# AWNING INSPECTION AND WELD/SEAM REPAIR

Recall Number:	22E-055		
Product:	Awnings		
Date:	Original: July 15, 2022	Labor Rate:	.30 hours inspection only     .30 hours repair only 1.5 hours fabric replacement only
	Current: Sept. 1, 2022

**NOTE:** This document supersedes the previously-released version dated July 15, 2022. All sections highlighted in yellow have been updated from the original version.

**Fig. 3**

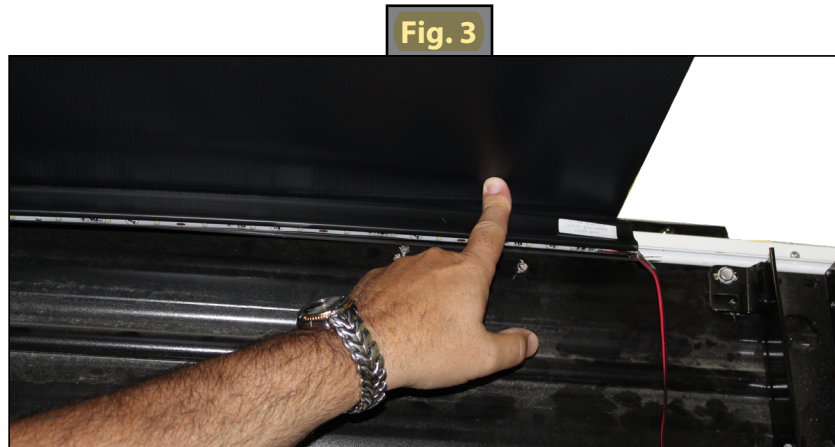
1. Extend the awning.
2. From underneath the awning, about 1" to 1.5" from the fabric edge, push up on the fabric with one finger (Fig. 3) until the awning fabric is flush with the top of the awning rail. Look for any separation or visible daylight at the seam. Perform push test at both ends of the awning.

**Fig. 4**

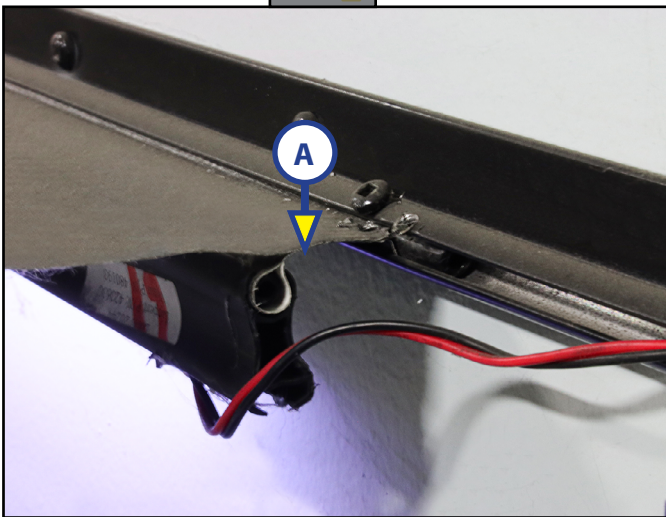
1. Position stepladder next to the unit to view the topside of the awning at the unit wall from either end (drive/idler side).
2. Inspect the weld near the awning rail (Fig. 4A).
  - A. Fig. 4 shows no separation at the seam. It does not require repair or replacement.
  - B. Fig. 5 shows separation at the seam (Fig. 5A).
    - I. If the separation is less than 6 inches, repair can be accomplished using the procedure described in [TI-434](#).
    - II. If the separation is over 6 inches it will require awning fabric replacement using the procedure described in [TI-166](#).
